**GOVERNMENT OF THE DISTRICT OF COLUMBIA
DEPARTMENT OF TRANSPORTATION**

MEMORANDUM

SUBJECT: Zoning Commission Case No. 14-14 – Jemal’s CDC, 501 H Street NE

Figure 1. Site Design and Access (Source: Applicant)

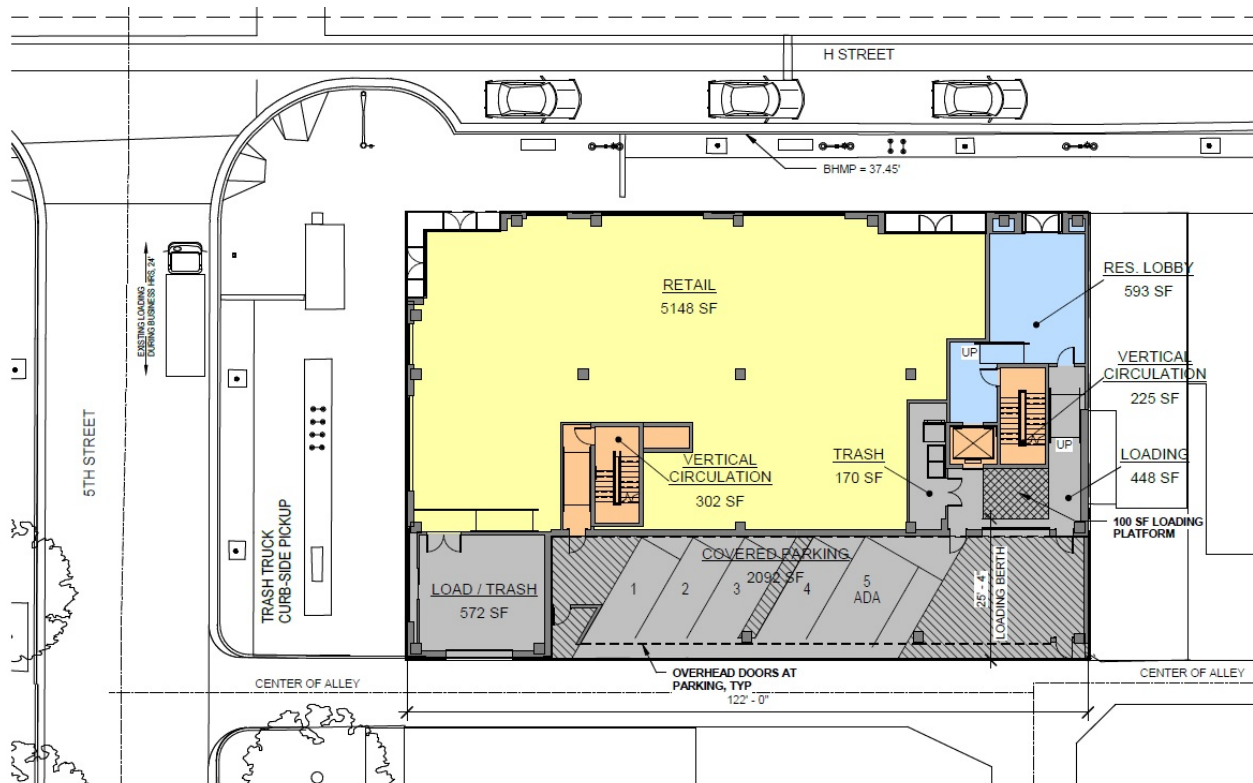
This Site is located at the southeast corner of the intersection of 5th Street and H Street, with an alley at its rear. The 11' alley passes through from 5th Street to 6th Street, going behind the proposed development, and is relatively narrow. Another portion of the alley connects south, ultimately also reaching 6th Street. The Applicant proposes vehicle and loading access via the alley network. This would serve the building from the rear, allowing access to three compact vehicular parking spaces, one car share space, and one handicapped-accessible space, along with a 24' loading berth. The proposed site access is consistent with DDOT's approach to site access, which seeks alley access and that the number of curb cuts be minimized.

The Applicant is seeking relief from the 30-foot loading dock requirement. A loading berth has been supplied for 24' trucks at the building's rear. This proposed alley loading location is consistent with DDOT's loading requirements. The Applicant's submittal includes AutoTurn analysis showing that truck maneuvers can be accommodated with front-in/front-out movements, in keeping with DDOT standards, and as shown on *Figure 2*.

Trucks that are too large to utilize the on-site loading facility may also occasionally need to serve the project. And while H Street has a parking lane, streetcar service at this location does not allow for loading activities to occur as the parking lane is too narrow to allow truck parking without interference with streetcar operations. An existing loading zone is located on 5th Street, which can be utilized for this purpose, but which will require trucks to move through the neighborhood to access.

Trash will be picked up curbside within the loading zone, as also shown in *Figure 2*, which will necessitate movement of the trash from the trash rooms, one of which is located at this corner of the building, to this area.
